MONTGOMERY COUNTY PLANNING DEPARTMENT
THE MARYLAND-NATIONAL CAPITAL PARK AND PLANNING COMMISSION

MEMORANDUM

6214 VERNE STREET (120080330)

RE: Preliminary Plan #1-20080330
6214 Verne Street

TREE SAVE PLAN
 PART OF PARCEL C
 COUNTRY CLUB VILLAGE
 A.F.E. HORN'S SUBDIVISION
 & ABANDONMENT OF VERNE ROAD
 MONTGOMERY COUNTY, MARYLAND

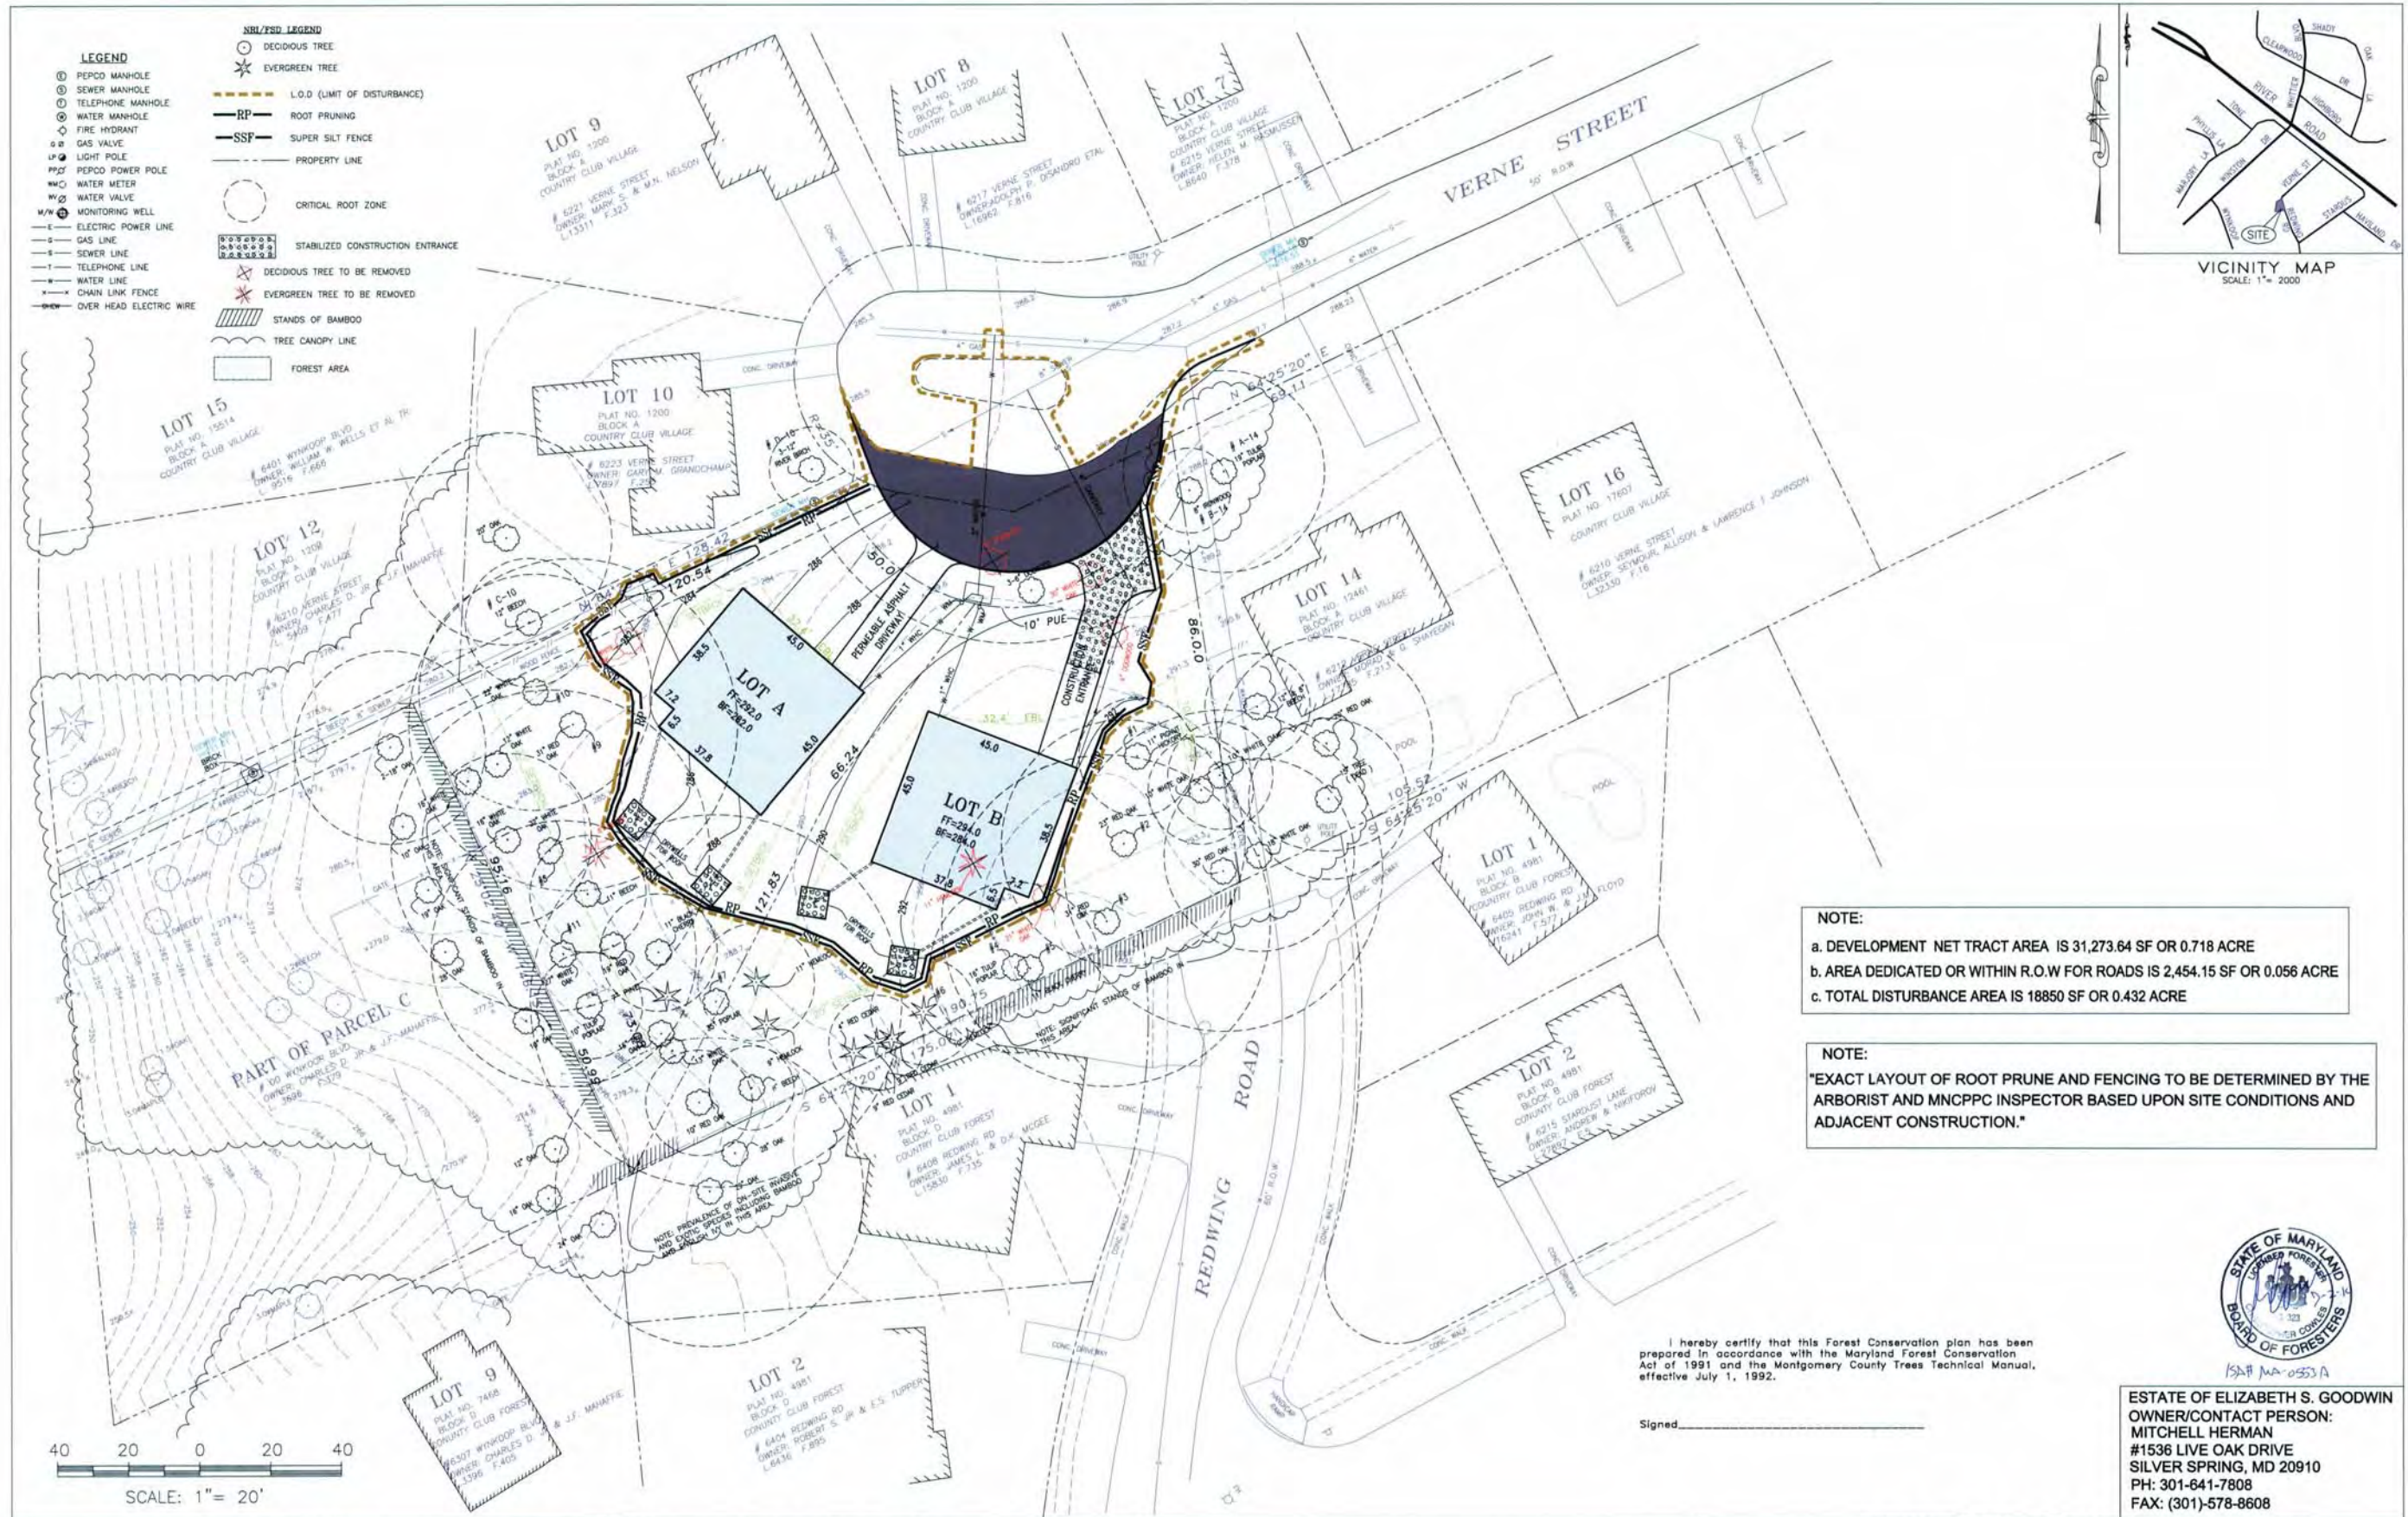
As this property does propose to remove specimen trees, it is subject to the Section 22A-6(b) tree save plan provision. A tree save plan with detailed and specific tree protection measures was prepared by an ISA-certified arborist and submitted with the preliminary plan. The plan shows the removal of one specimen (30” white oak) and one significant (24” white oak) tree. The other significant and specimen trees will be protected through a combination of restricted LOD and tree protection measures. Because the application is exempt from forest conservation requirements, removal of the specimen trees does not require approval of a forest conservation variance.

1. Primary review of civil site plan / tree save plans with recommendations.
2. Site visit to assess trees of possible impact from proposed construction.
3. Marked latest plan, assign tree numbers, and updating tree data.
4. Develop a tree preservation matrix of recommended protection and stress reduction strategies based upon anticipated impact and TPA.

Erosion and Sediment Control: Erosion & Sediment Controls should be reviewed by the project arborist for impact to TPAs. Silt fence (SF) on the LOO within CRZs of designated key trees may require consideration of the "non-invasive" SF option to avoid damage to upper level root systems common in conventional design details and installation. Coordination with the county reviewer / inspectors is typically in order with this change. Approval in several agencies in Maryland and Virginia on a site by site basis has developed a considerable track record of success.
